Service Bulletin

Bulletin No.: PIT6300C

Subject: Buzz, Rattle, Vibration Noise from the Passenger Side When Vehicle Is Under Light Load - Possible Slow/No Crank Or Alternator Not Charging

6908613

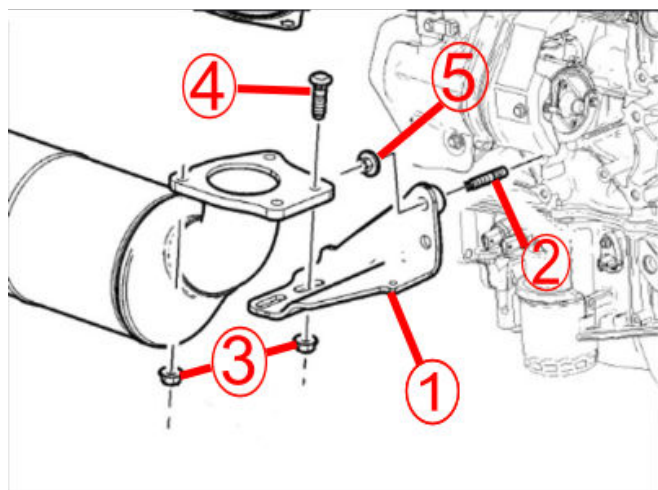
Involved Region or Country	North America
Condition	Buzz/Rattle/Vibration/Noise from the passenger side when the vehicle is under light load. Possible Slow/No Crank or alternator not charging.
Cause	Inspect for a cracked catalytic converter bracket (1), and/or missing/broken hold down studs (2,4), as shown below.

Inspect the catalytic converter brace/bracket for cracks or missing hold down stud and/or nuts.

Repair as needed.
